The author created a dataset of storage tanks using a deep learning approach applied to high-resolution remote sensing imagery. This dataset provides a comprehensive, validated, and geo-referenced collection of details, including the precise locations, distributions, and construction years of storage tanks. It covers 92 representative cities, encompassing a total of 14,461 tanks. The manuscript also explores the spatial correlations between the distribution and density of storage tank and methane emissions, contributing to a more profound understanding of the societal, ecological, and settlement impacts of methane emissions from these structures. The paper's innovation lies in its comprehensive database of storage tanks across 92 typical cities and its large-scale exploration of the spatial interplay between storage tanks and methane emissions. However, there are some problems that require responses from the authors. Afterwards, this manuscript could be accepted for publication after a minor revision.

Figure 10. Distribution pattern of storage tank pixels with different CH₄ emission estimations: (A) Proportion of pixels with different CH₄ emission estimations; (B) box plot of CH₄ emission (Tg CH₄yr⁻¹) of storage tank points and background object points.

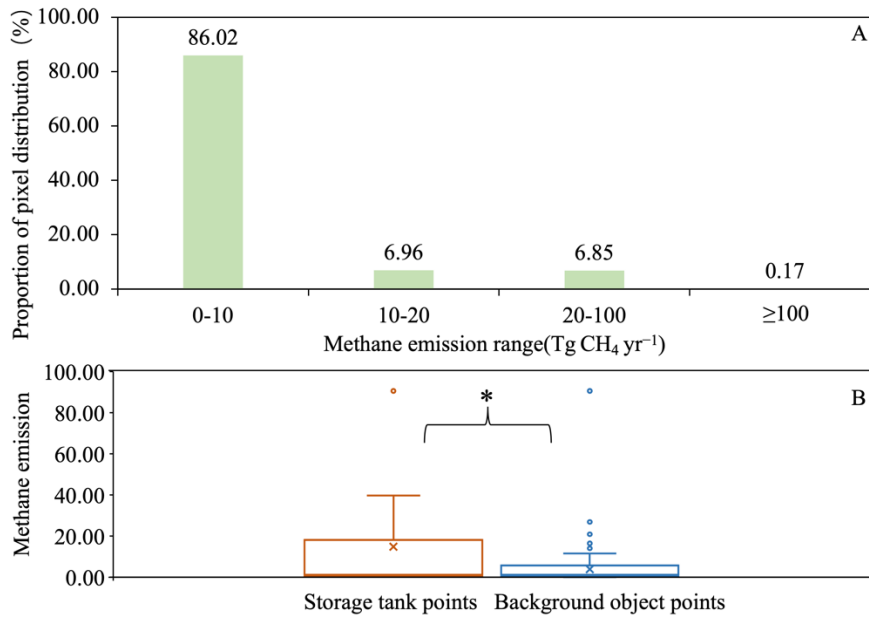
Line 475-476: In figure 10 (A), the “CH4” should be “CH₄”. In figure 10 (B), the unit “Tg CH4 yr⁻¹” of methane emissions of left panel is necessary after “Methane emission”.

Answer: Sorry for the error we made. ‘CH4’ has been corrected to be ‘CH₄’ in the revised Figure 10(A). The unit ‘Tg CH₄yr⁻¹’ has been added in the caption of Figure 10(B). For your convenience to check, the revised Figure 10 has been listed below.
